Comments re: RSPP

*****Formal comments on the Staff Assessment / Draft Plan Amendment / Draft Environmental Impact Statement (SA/DPA/DEIS) are due to the Energy Commission, no later than 5 p.m., May 21, 2010. The comment deadline for the Bureau of Land Management is July, 8, 2010.**

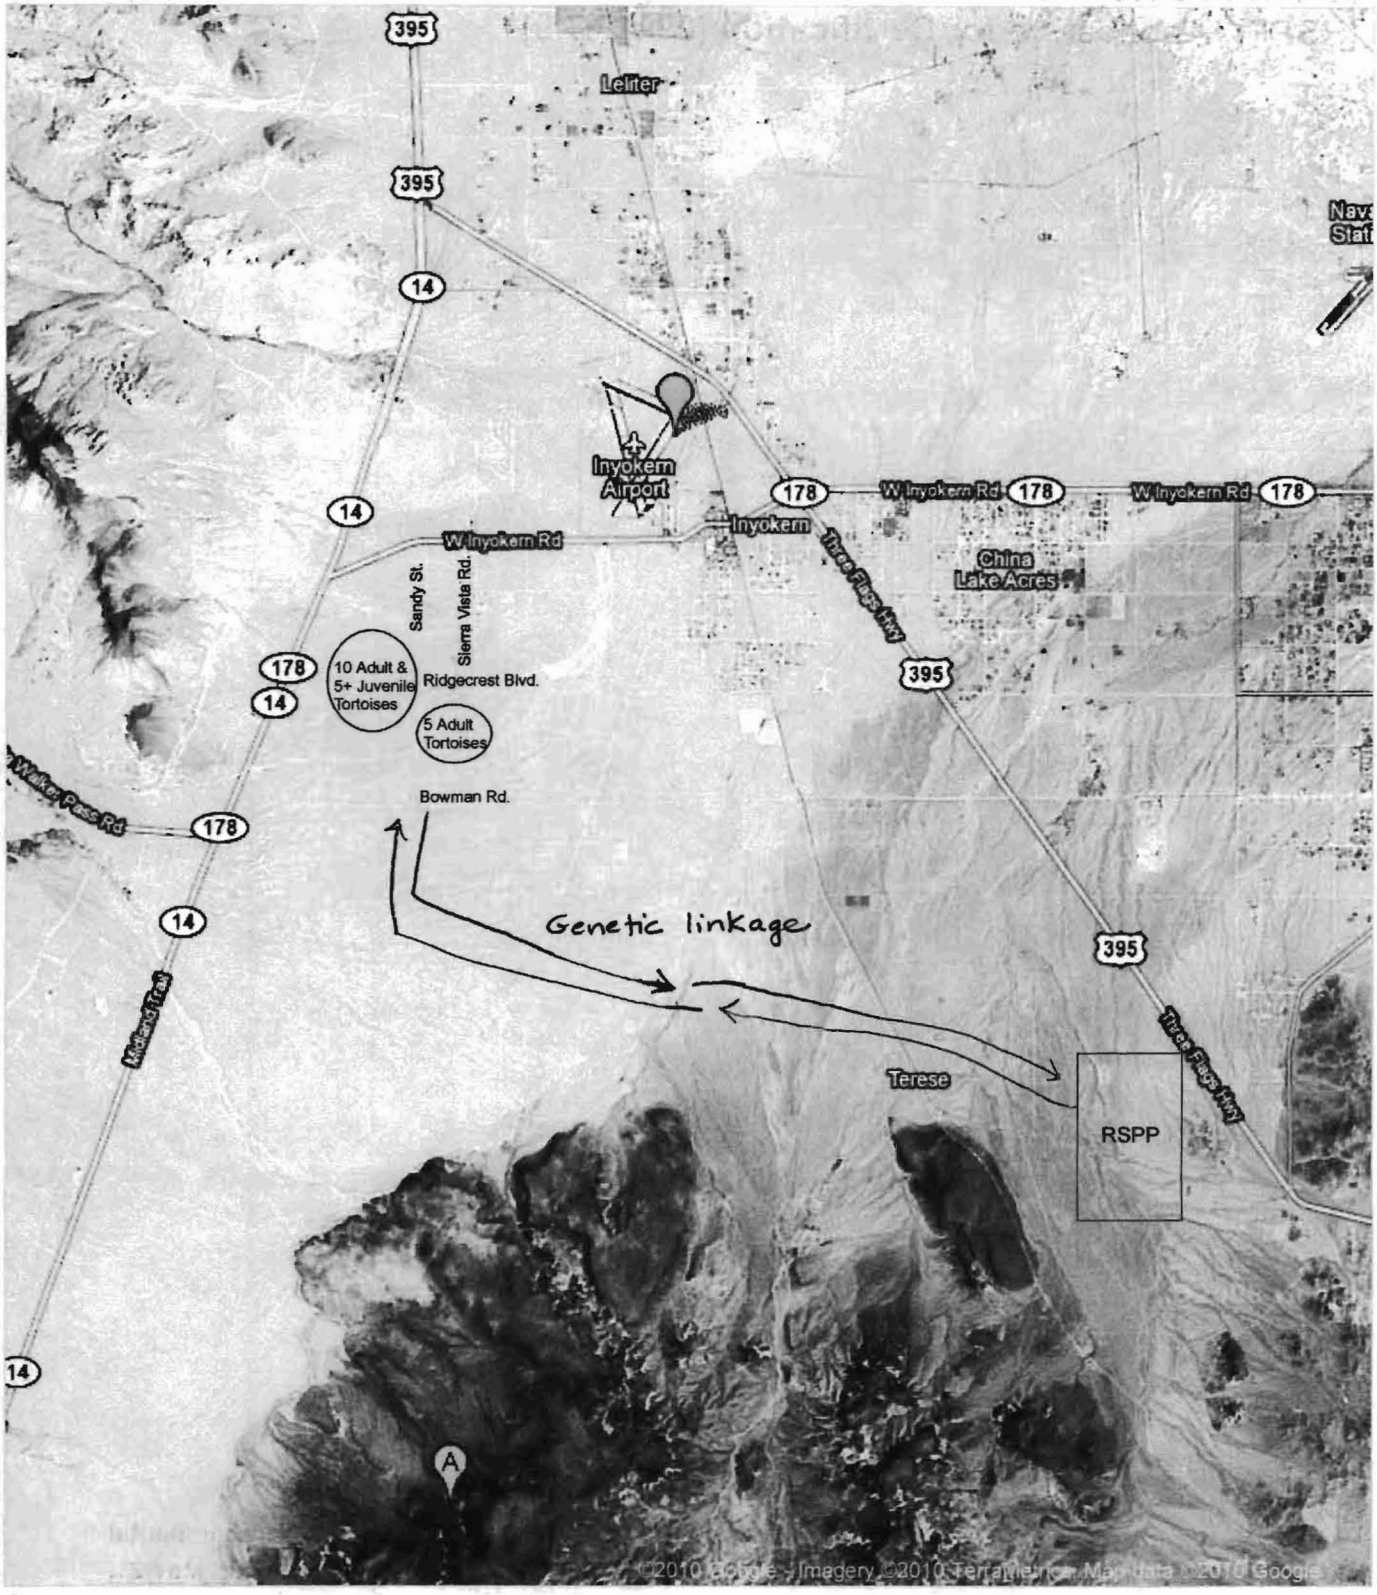
The RSPP site has been called an important connecting corridor for genetic linkage of tortoises + MGS. I have enclosed a map (page 3) supporting this connectivity issue. In my neighborhood, many tortoises live on the BLM lands to the west of Sandy + south of Ridgecrest Blvd. This is another little-Known pocket of tortoises that ~~are~~ is connected to the RSPP site tortoises via the Little Dixie Wash Area.
